Power Steering Fluid Leaks—Mercury Diesel Sterndrive Engines Models Affected

Description	Serial Number Or Year
Mercury Diesel Sterndrive engines—2.0L I4, 2.8L I4, 4.2L I6, 3.0L V6 TDI, 4.2L V8 TDI	2015 and earlier

62455

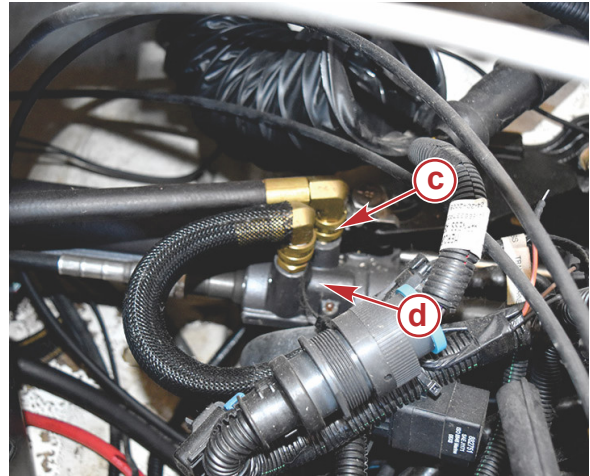
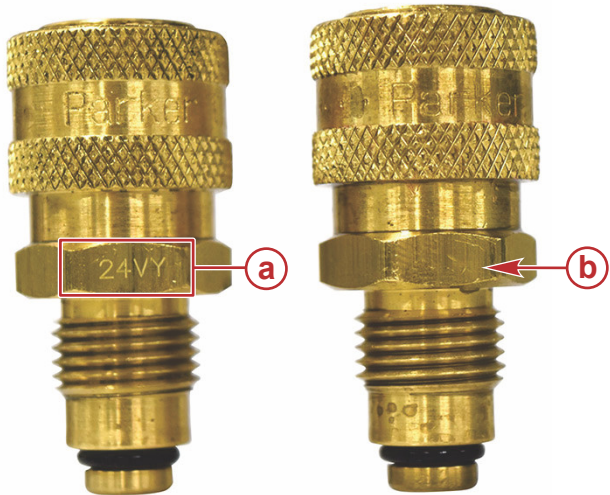
1. Inspect any inventory of power steering cylinder assembly kits for a power steering quick-connect return fitting without a date code. Refer to **Parts Affected** for the cylinder assembly part number. Follow the instructions in the **Warranty** section of this bulletin, and return kits that do not have a date code.
2. Inspect any loose inventory of power steering quick-connect return fittings for a date code. Refer to **Parts Affected** for the fitting part number. Follow the instructions in the **Warranty** section of this bulletin, and return any loose power steering quick-connect return fittings that do not have a date code.

NOTE: The date code is only visible on one flat of the fitting. Be sure to check all sides of the fitting while attempting to locate the date code.

- a** - Power steering quick-connect return fitting with date code
- b** - Power steering quick-connect return fitting without date code
- c** - Power steering quick-connect return fitting location
- d** - Power steering cylinder assembly

62454

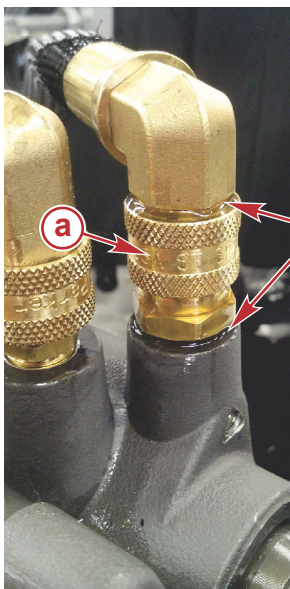
3. Inspect the power steering quick-connect return fitting on systems mounted in vessels. Run the engine if necessary. The presence of residual fluid around the fitting indicates a leak. If residual fluid is found, replace the power steering quick-connect return fitting.

- a** - Power steering quick-connect return fitting
- b** - Power steering residual fluid
